UNITED STATES PATENT AND TRADEMARK OFFICE

APPLICATION NO.	FILING DATE	FIRST NAMED INVENTOR	ATTORNEY DOCKET NO.	CONFIRMATION NO.
10/628,749	07/28/2003	Philip G. Wessells	20003-7003	4857
35939	7590	07/02/2004	EXAMINER	
MICHAEL E. WOODS PATENT LAW OFFICES OF MICHEAL E. WOODS 112 BARN ROAD TIBURON, CA 94920-2602			COLILLA, DANIEL JAMES	
			ART UNIT	PAPER NUMBER
			2854

Office Action Summary

DETAILED ACTION

Isobe discloses an image transfer apparatus including a housing as shown below taken from Figure 2 of Isobe:

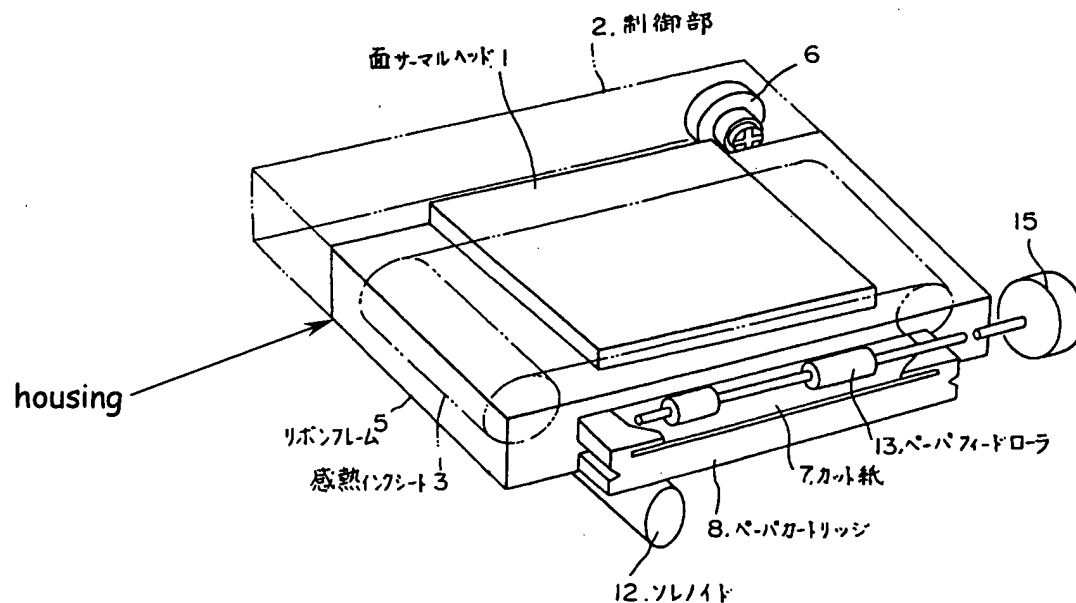
8. Claims 1 and 4 are rejected under 35 U.S.C. 102(b) as being anticipated by Isobe (JP 61-095962).

a transfer engine 1a (as shown in Figure 1 of Isobe) and a transfer medium registration system 8,9 coupled to the transfer engine through the housing. *Note: "for use" statements are not given any patentable weight.*
